ADDENDUM 01

UMA EASTPORT HALL HVAC RENOVATIONS PHASE II University of Maine at Augusta

Date: April 18, 2025

M-4

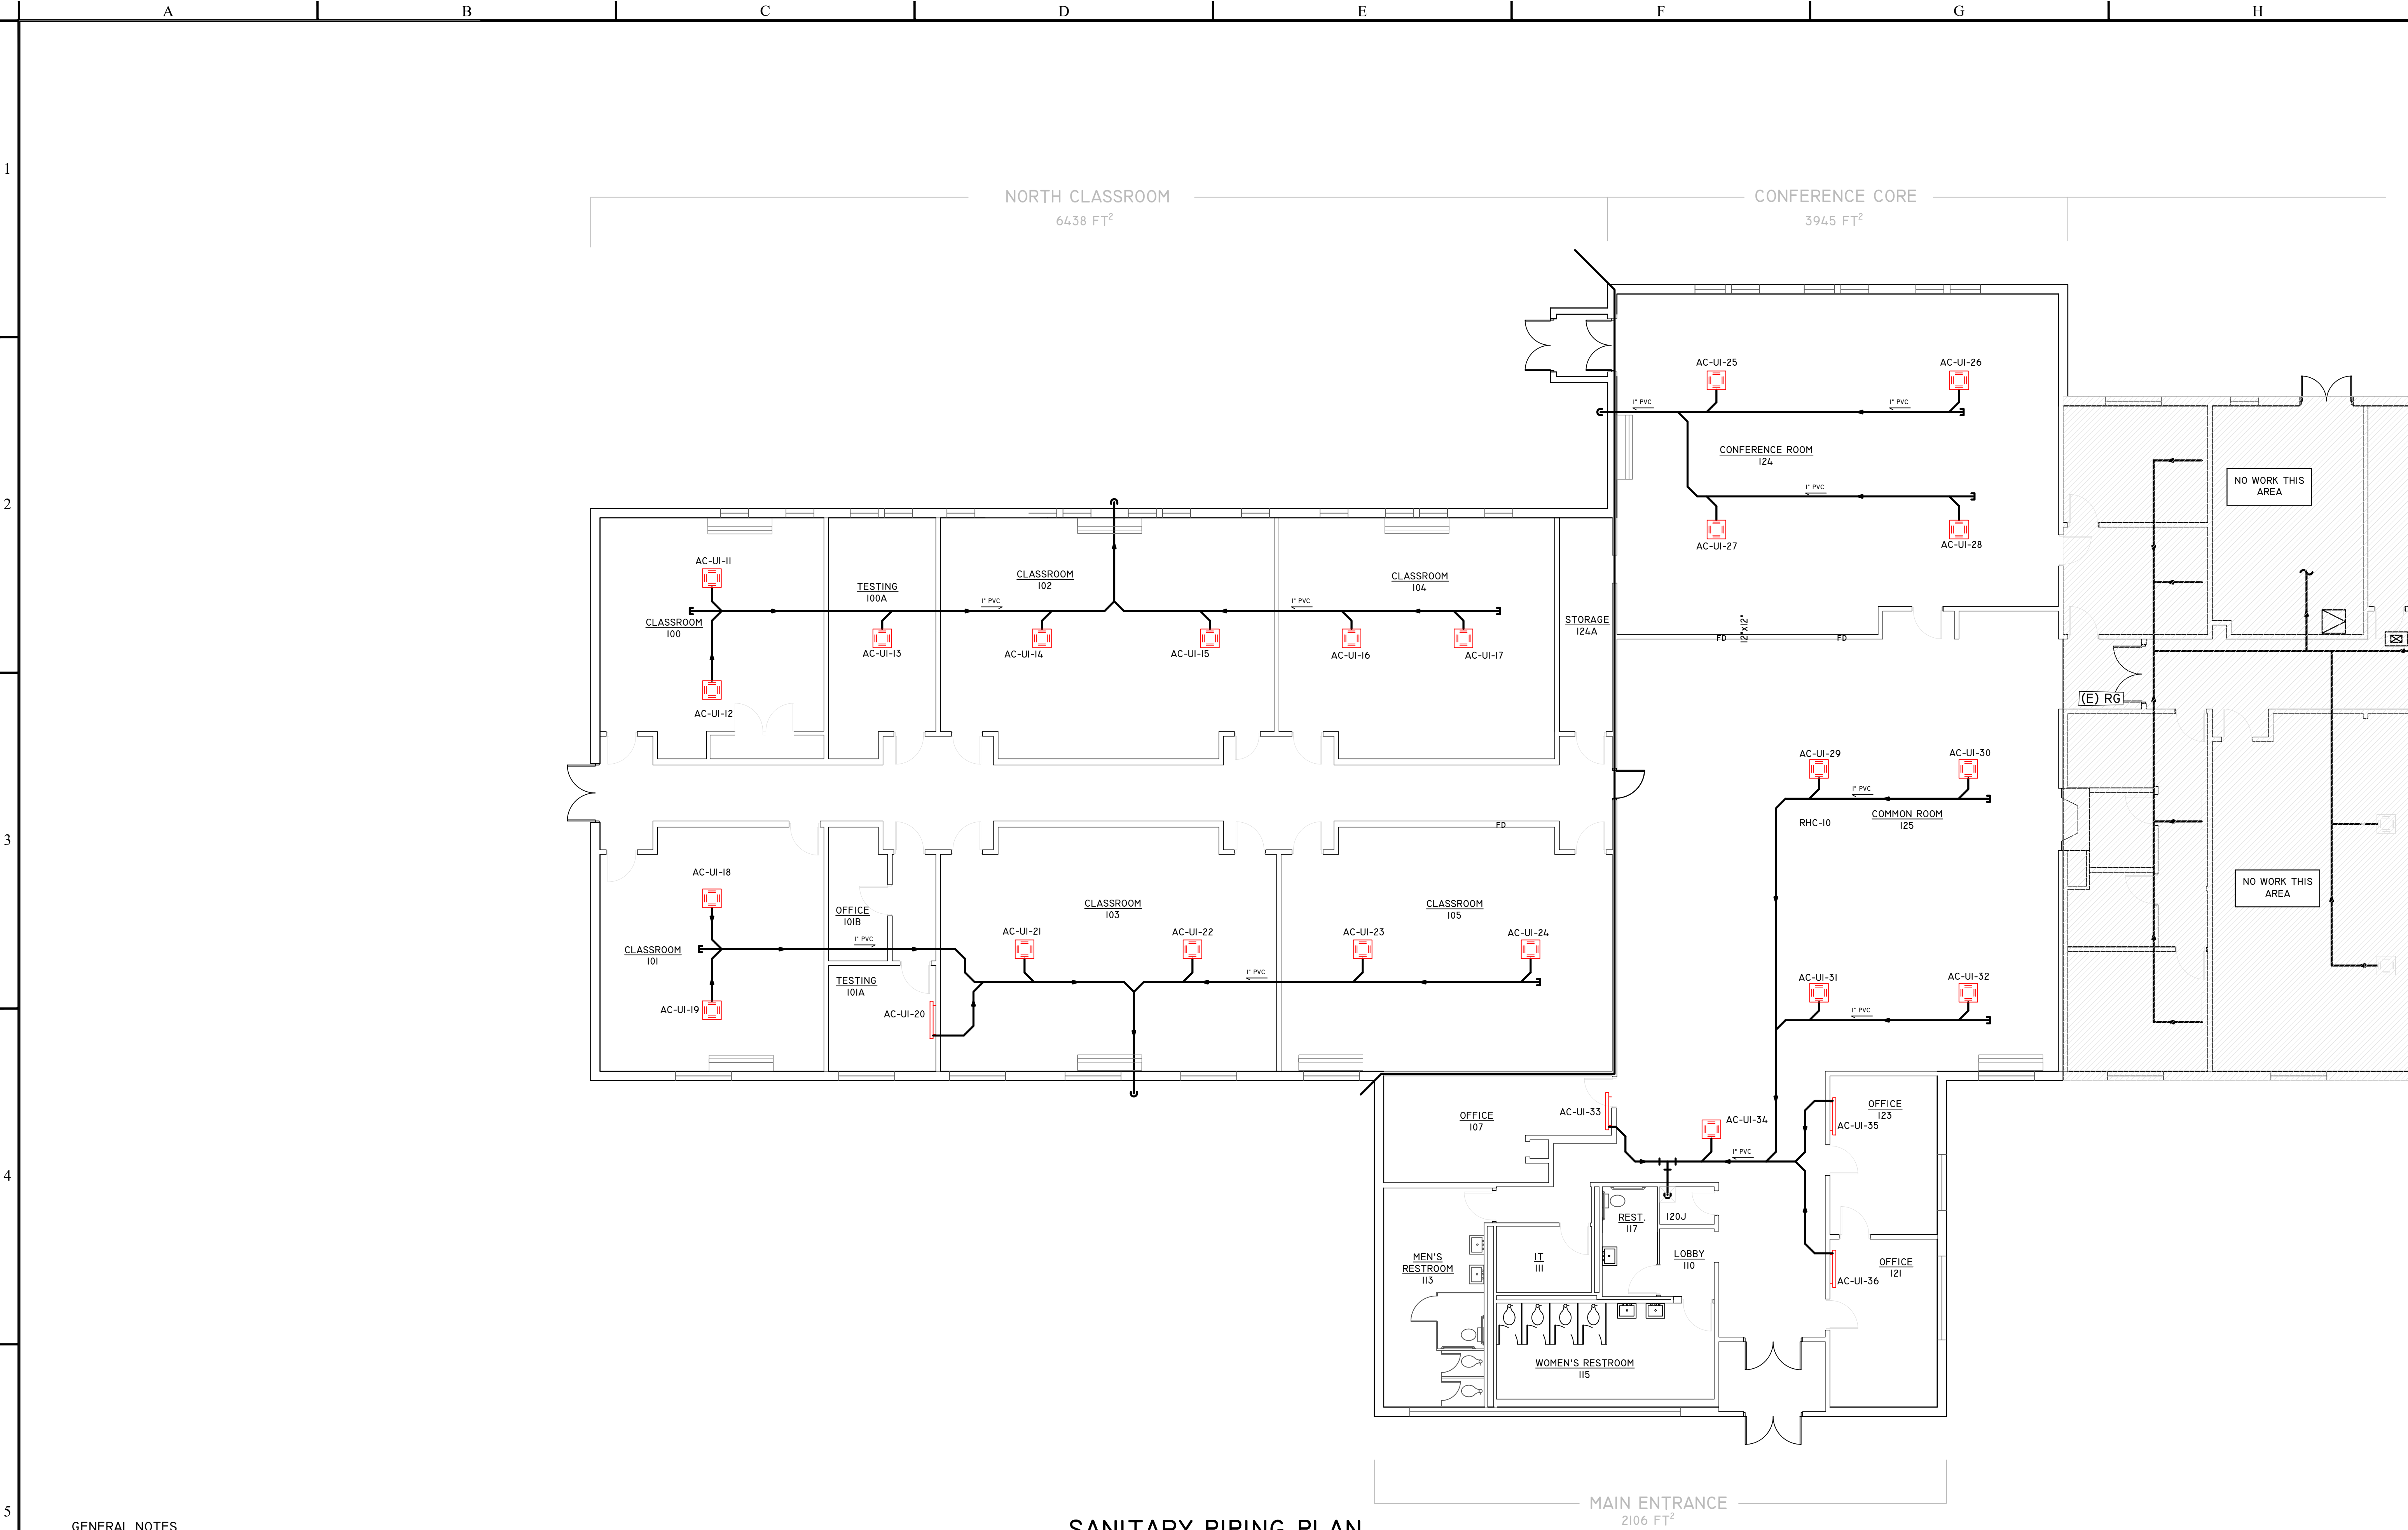
4. *Are the Unit Ventilators shipped "control ready"?*

Drawing M-4: Unit Ventilator Equipment Schedule: Add note to read, "Control Ready".

Response: The unit ventilators will be provided "Control Ready" per this Addendum #1.

Division 23 00 00: Unit Ventilators shall be provided "Control Ready" from the manufacture.
